UNITED STATES PATENT AND TRADEMARK OFFICE

10/756,886

Office Action Summary	Application No. 10/756,886	Applicant(s) LEUNG ET AL.	
	Examiner James R. Harvey	Art Unit 2833

DETAILED ACTION

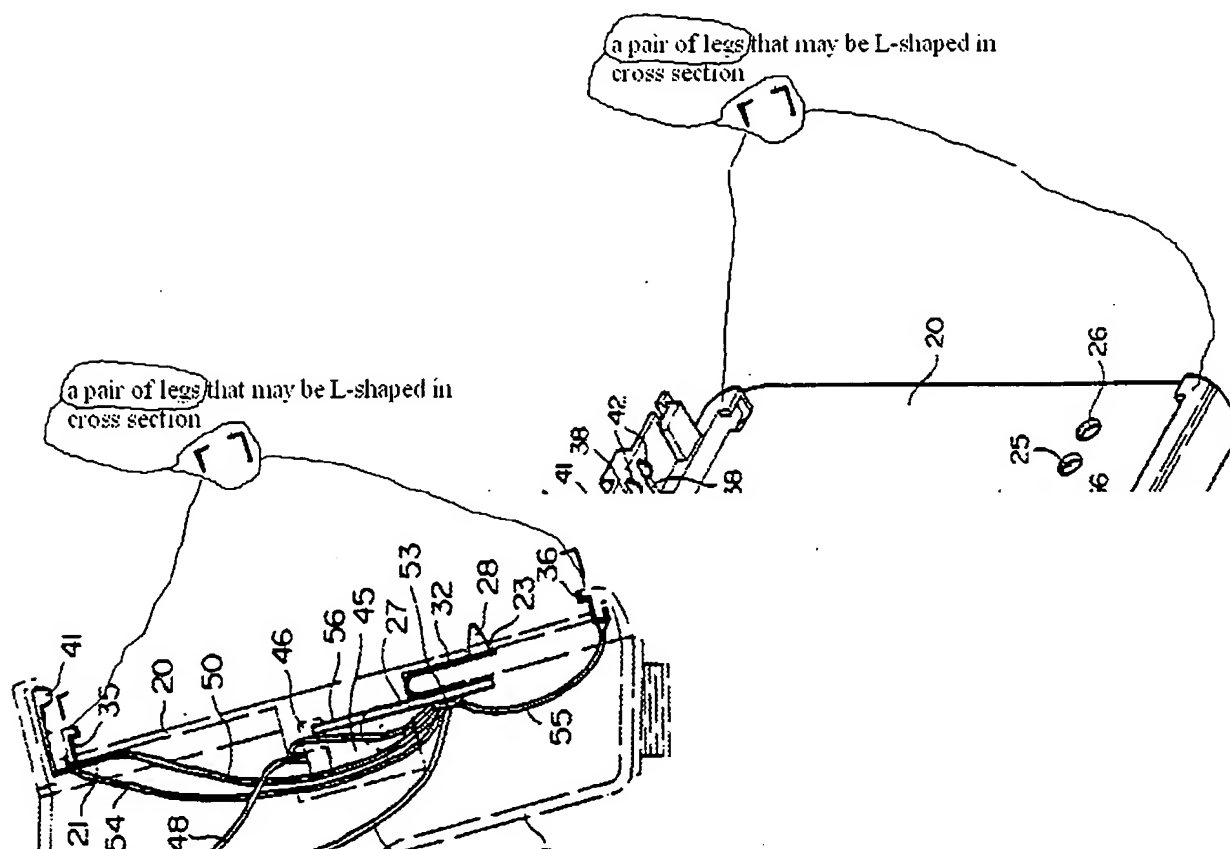
-- In reference to Claim(s) 4, Applicant's specification (page 7, line 7) describes the holding strap as a pair of legs that may be L- shaped in cross section. Huang shows (figure 4 and (cover sheet)) the member 15 has a holding strap that is a pair of legs that are L-shaped in cross-section (see examiner's figure) configured to retain the member 15 adjacent the end of the battery.

-- In reference to Claim(s) 14, Applicant's specification (page 7, line 7) describes the holding strap as a pair of legs that may be L- shaped in cross section. Huang shows (figure 4 and (cover sheet)) the member 15 has a holding strap (see examiner's figure) configured to retain the member 15 adjacent the end of the battery.
